Re: PA23-026 – Cornelius Lacey PRD – Technical Review 2

MEMORANDUM

TO: Amy Hess – Senior Planner
FROM: Jesse Hannahs, P.E. – Traffic Engineering Manager
DATE: February 28, 2024
SUBJECT: PA 23-026 – Cornelius Lacey PRD

Figure 1. Tall retaining walls must be terraced with landscaping as depicted below.

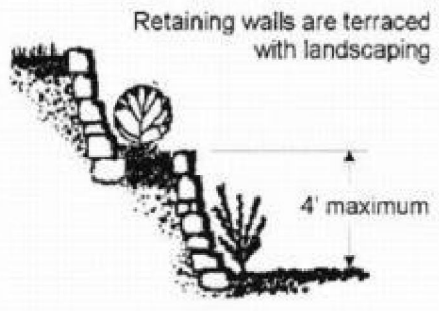
1. Pursuant to [MMC 22D.050.030\(4\)\(e\)](#), if retaining walls taller than four feet are used, and are visible from the street or adjacent property, they shall be terraced so that no individual segment is taller than four feet. Any walls ultimately permitted exceeding 4 feet shall comply with these requirements. Walls on lots 4, 38-43, 18, 10, 57, and 5, as well as some others, have walls exceeding 4 feet. ***These will need to be terraced per the standard below***, and depicted on the plans. The landscape plan does not depict plantings that will screen many of these proposed walls.

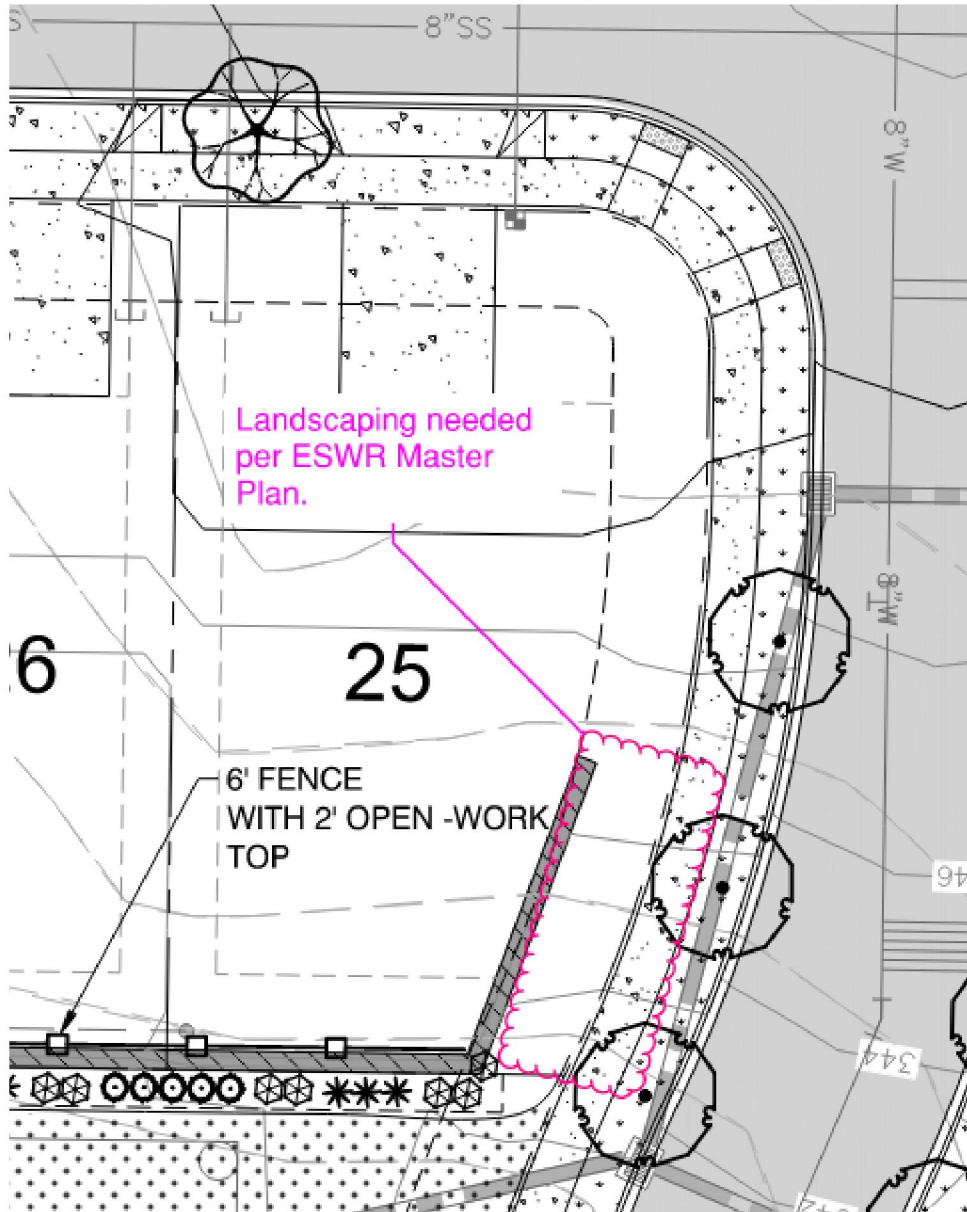
3. In development configurations where side yards abut a street, fences taller than 3-1/2 feet shall be setback at least 5 feet from the sidewalk to allow for landscaping to soften the view of the fence. Provisions for long-term maintenance of this landscaping shall be addressed on the plat. **Additional landscaping is needed along the wall on the southern portion of lot 25.**
